HISTORIC AND DESIGN REVIEW COMMISSION

HDRC CASE NO: 2021-052
ADDRESS: 418 MISSION ST
LEGAL DESCRIPTION: NCB 945 BLK 2 LOT 32
ZONING: RM-4 CD, H
CITY COUNCIL DIST.: 1
DISTRICT: King William Historic District
APPLICANT: Deniese Crittenden/SCHEFF DENIESE M & CRITTENDEN ROBERT JR
OWNER: Deniese Crittenden/SCHEFF DENIESE M & CRITTENDEN ROBERT JR
TYPE OF WORK: Front yard fence installation
APPLICATION RECEIVED: January 25, 2021
60-DAY REVIEW: Not applicable due to City Council Emergency Orders
CASE MANAGER: Rachel Rettaliata

The applicant is requesting a Certificate of Appropriateness for approval to install a 3-foot-high wrought iron front yard fence.

SURVEY OF: LOT 32, BLOCK 2, NEW CITY BLOCK 945, SITUATED
 WITHIN THE CORPORATE LIMITS OF THE CITY OF SAN ANTONIO,
 BEXAR COUNTY, TEXAS.

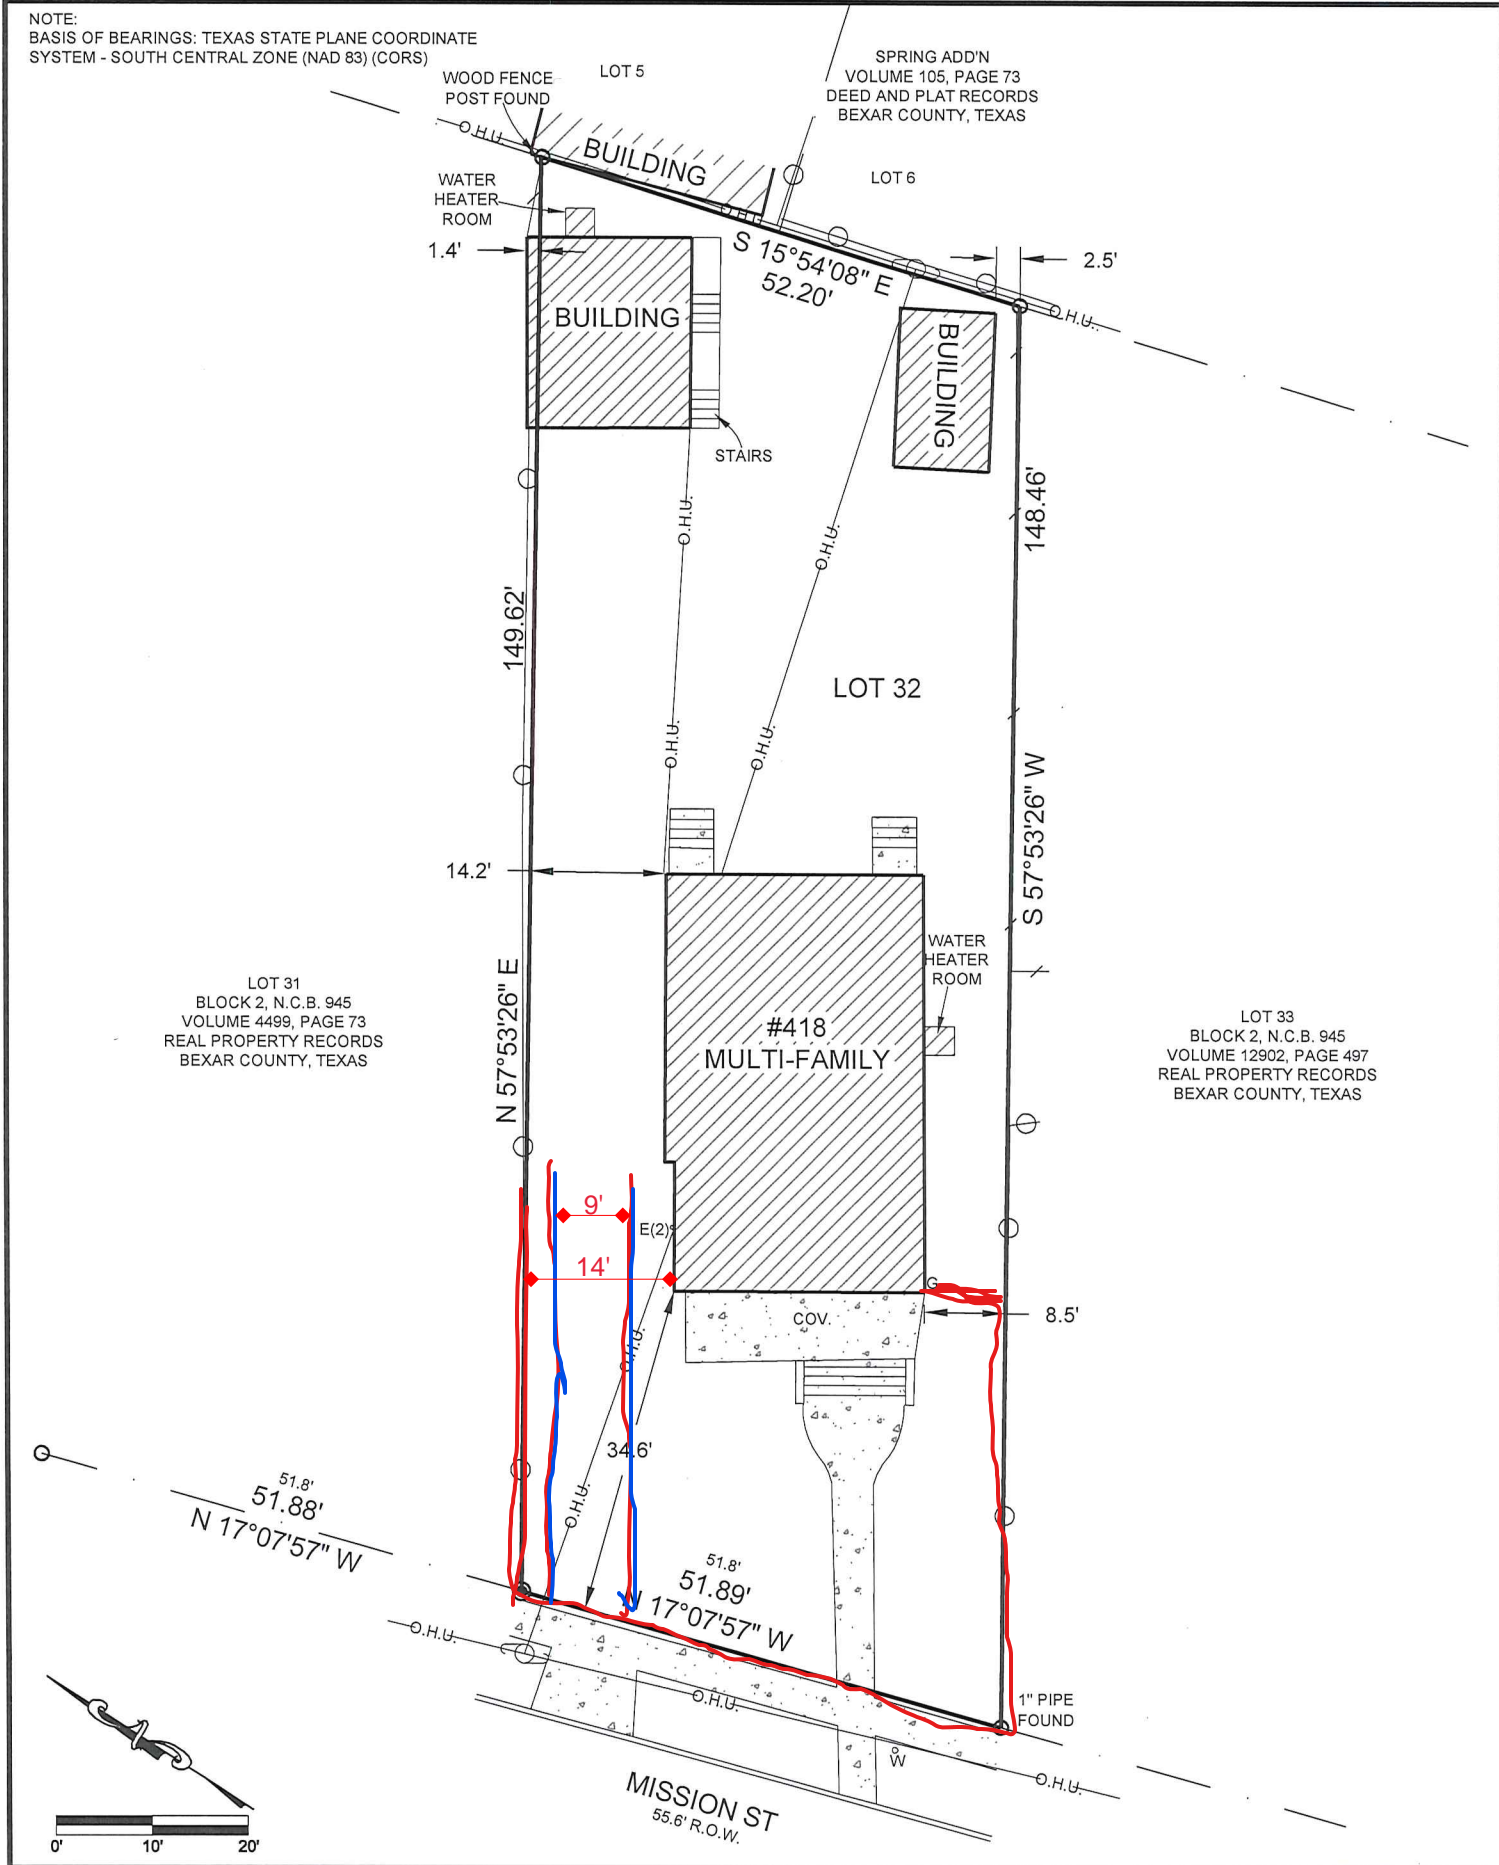
- c. FENCE LOCATION – The applicant has proposed to install a 3-foot-tall wrought iron fence with a pedestrian gate and a front driveway gate at the intersection of the property line and the sidewalk. According to the Historic Design Guidelines, new front yard fences should follow historic fence placements in the district. This block of Mission Street currently features wood picket, cattle panel, garden loop, and wrought iron front yard fencing. Many of the existing fences on Mission Street feature front driveway gates; however, most of these properties feature unique site conditions that necessitate a front driveway gate. Staff finds that the proposed front yard fence at Mission Street should turn at the driveway and the proposed driveway gate should be installed behind the front façade wall plane.

- i. That the applicant submits an updated site plan to staff for review and approval showing that the driveway gate is located behind the front façade wall plane.
- ii. That the final construction height of the approved gate and fencing may not exceed the maximum height of 4 feet as approved by the HDRC at any portion of the fence. Additionally, the fencing must be permitted and meet the development standards outlined in UDC Section 35-514.
